# PARTS & SERVICE NEWS

REF NO.	AA02170A
DATE	October 29, 2002

**SUBJECT:** IMPROVED FOUR PIECE RADIATOR FAN GUARD

**PURPOSE:** To inform the field of a new, improved four piece fan guard.

FIGURE 1. IMPROVED FAN GUARD

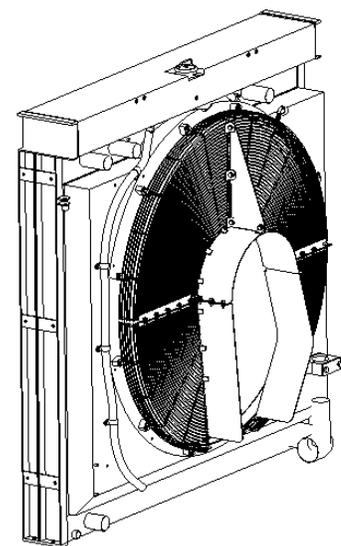
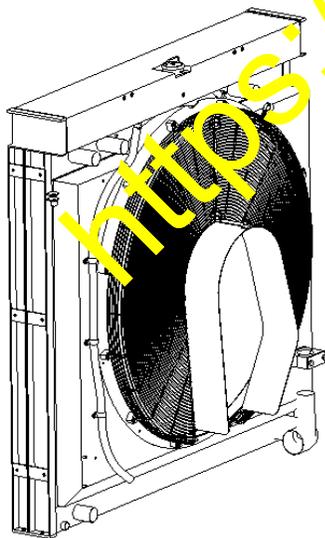
A new fan guard has been designed to improve maintenance access. The four piece design allows fan guard removal without interference from the right hand water tube. The new fan guard will be factory installed on trucks A30078 and up. Refer to Figure 1 for an overview of the changes and Figure 2 for installation details. The table below lists the necessary parts needed for conversion.

ORIGINAL 2 PIECE DESIGN

IMPROVED 4 PIECE DESIGN
